Multicast for Package A

Glen Kramer, Broadcom

Why do we need this change?

Intra-ONU Multicast Options

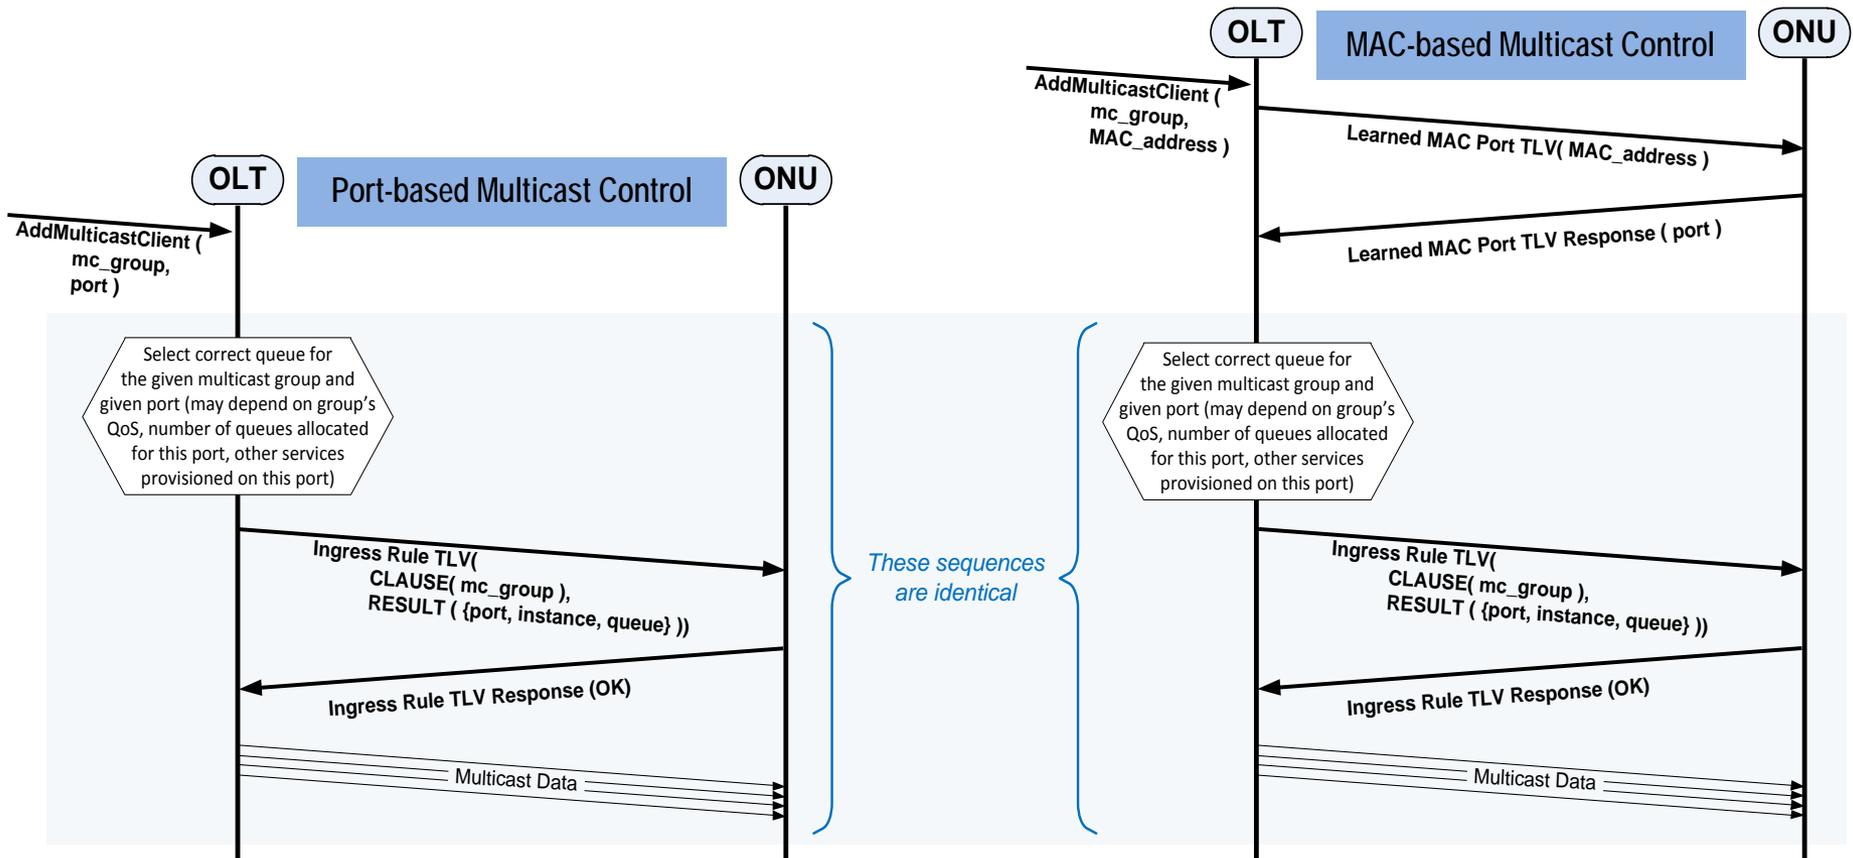
- ❑ Port-based Intra-ONU multicast control
 - If the OLT knows to which UNIs the multicast clients are connected, it can configure an ONU to forward multicast traffic to these exact ports.

- ❑ MAC-based Intra-ONU Multicast Control
 - If the OLT knows only multicast clients' MAC addresses, it needs the ONU to map these addresses to specific UNIs.

- ❑ Different UNIs may have different numbers of egress queues. OLT should be able to specify which queue to use at each UNI for the given multicast group.
 - This is easy to accomplish in Port-based multicast control because the OLT knows queue configurations for each UNI and it knows which UNIs are part of a given multicast group.
 - But in case of MAC-based Multicast Control, the OLT does not know a priori which UNIs are part of a given multicast group, so it cannot specify the proper queues.
